DESCRIPTIVE REPORT TO ACCOMPANY HYDROGRAPHIC SHEET 5407 LONG ISLAND SOUND
EAST RIVER AND EAST CHESTER BAY, PROJECT H & T 186, 1934.

HYDROGRAPHIC SHEET NO. ..5547

REVIEW OF HYDROGRAPHIC SURVEY NO. 5547 (1934) - FIELD NO. 5407

East Chester Bay, Long Island Sound, New York

To accompany H-5547

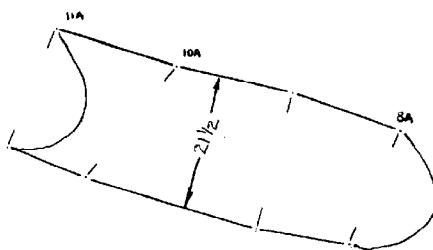
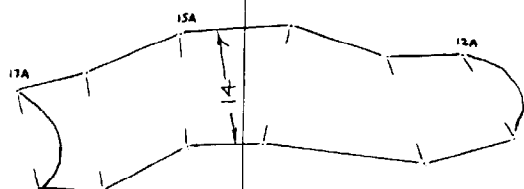
Detached Sdg of 5 feet
obtained here which is
plotted on smooth
sheet. *sum.*
